# Rezoning Transportation Analysis

Petition Number: 2024-018

General Location Identifier: 03149117, 03149118

## Revision Log:

### 1. ~~Curblines:~~

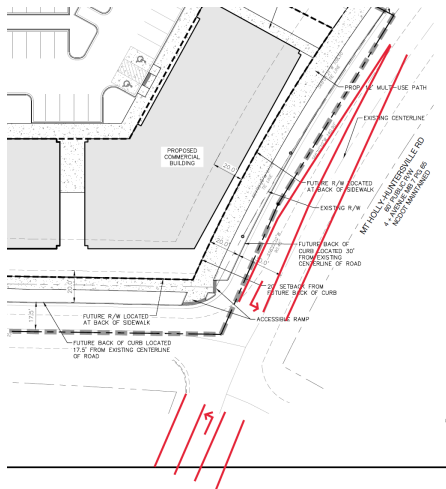
a. ~~Mt Holly Huntersville Rd:~~ The future location of curb and gutter is 30' from centerline.

4+ Avenue, Shared Use Path per the Charlotte Streets Map

b. ~~Harwood Lane:~~ The future location of curb and gutter is 17.5' from centerline.

~~CLDSM standard Local Collector Street U-07B~~

~~Label and dimension the curb and gutter from the centerline for each road on the site plan. Show proposed striping layout for Mt Holly Huntersville Road and commit to restriping for left turn lane on Mt Holly Huntersville Road at Harwood Lane.~~
